DOCKET NO. WEST14-00022 SERIAL NO. 09/839,457 PATENT

#### **REMARKS**

WEST14-00022 SHEET 3 OF 8

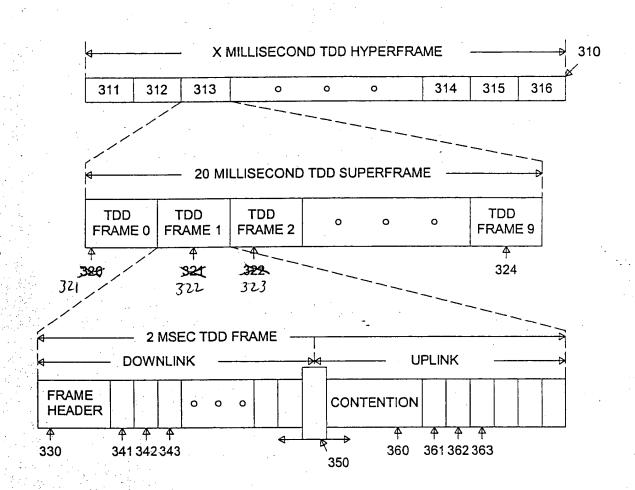
The Office Action objects to the drawings because of various informalities noted in the Office Action. The Applicants have amended Figures 3 and 6-8 to correct the noted informalities. In particular, the Applicants propose to replace reference numerals 320-322 with reference numerals 321-323 in Figure 3, remove one instance of reference numeral 600 from Figure 6, and remove reference numeral 100 from Figure 7 and Figure 8. The Applicants have also amended the specification to refer to reference numeral 507.
